Basis of the Request to Deepen the  
Hu Honua Bioenergy, LLC Disposal Wells  
UIC Application No. UH-3051

## Proposed Well Modifications to Achieve the Required Disposal Capacity

**Figure 1**  
**Well Section of Proposed Deepened Disposal Wells**

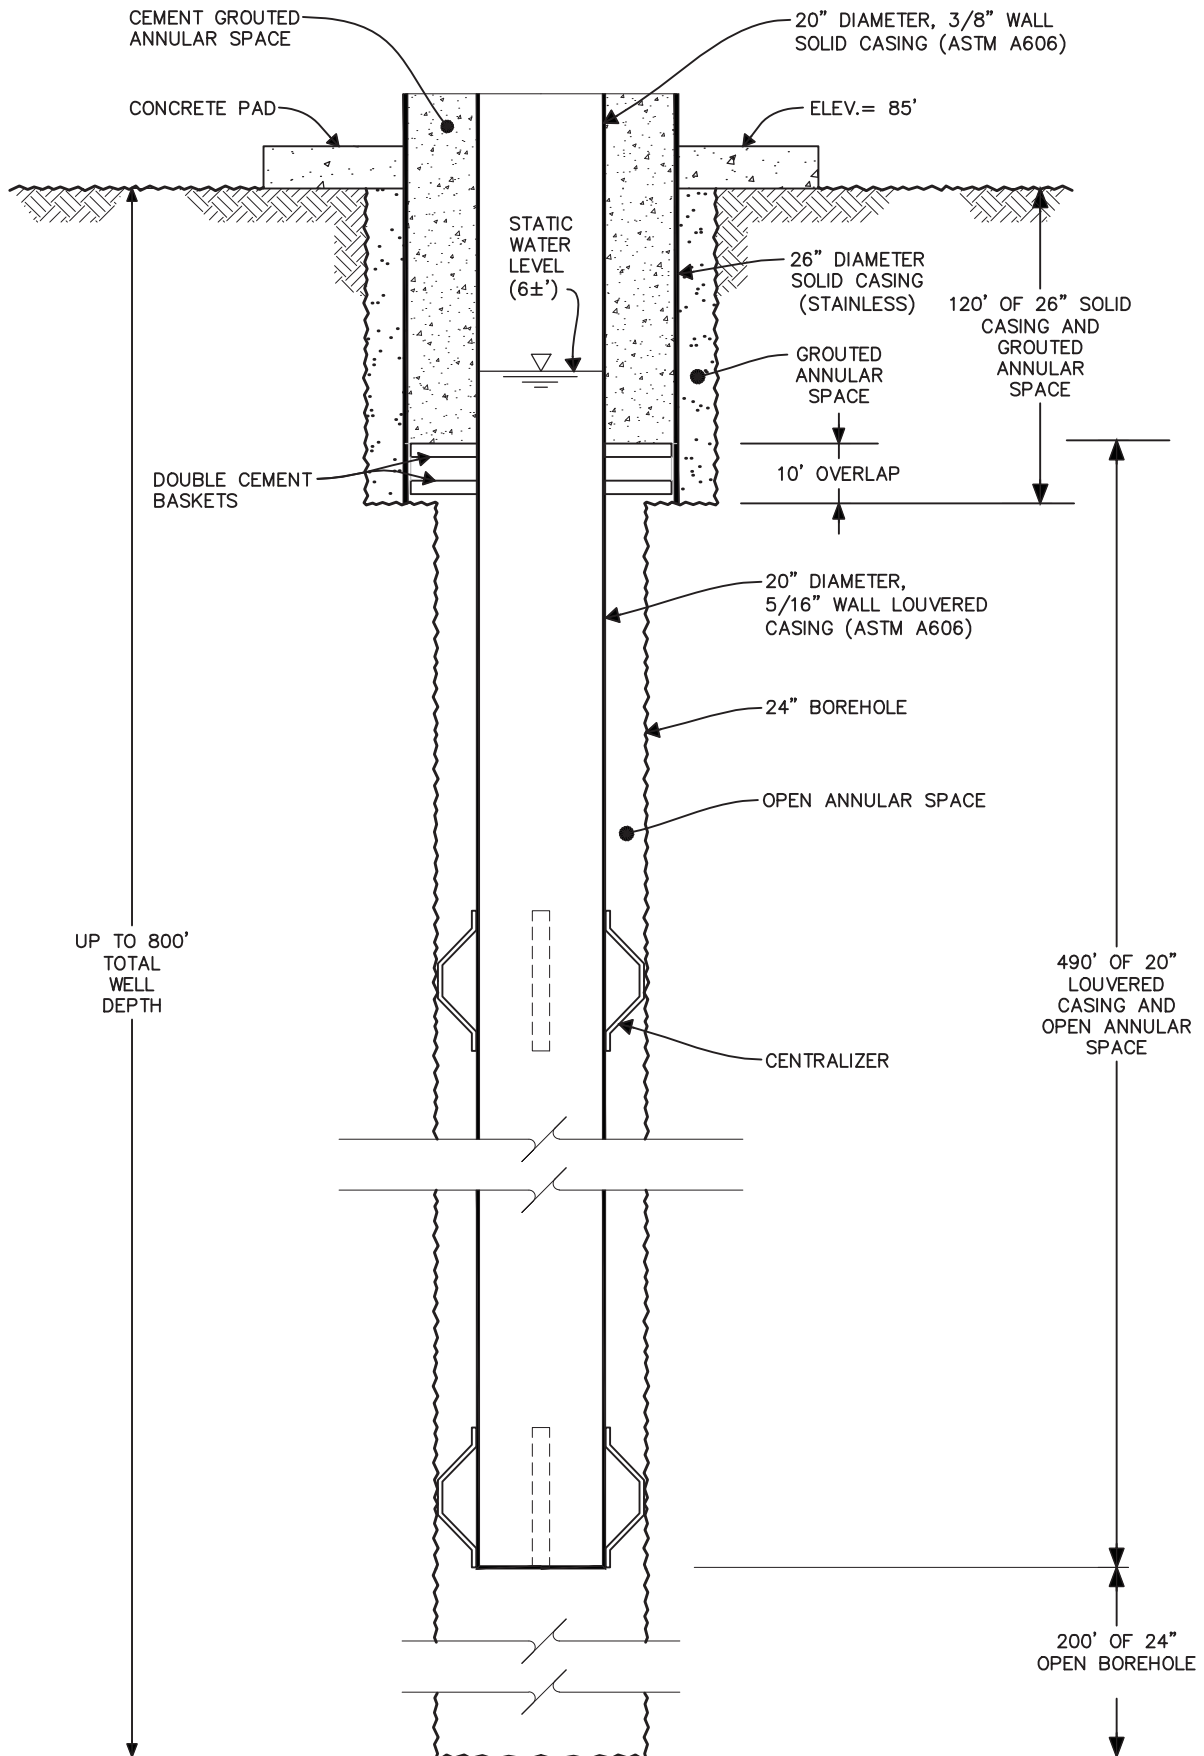
- The well depths would be increased from 400 to 800 feet;
- Louvered casing, which was not included in the original well design, would be installed; and
- Water would be delivered into the well with a drop pipe.

Figures 1 and 2 illustrate the revised well sections as proposed. Figure 2A schematically illustrates disposal into the well, down the drop pipe, and into the formation. The increased depth is needed to provide the required capacity. The louvered casing will allow rehabilitation of well disposal capacity by surge blocking as well as by pumping, improving the effectiveness of the rehabilitation. The use of the drop pipe for delivery into the well is to minimize air entrainment which can temporarily reduce disposal capacities dramatically.
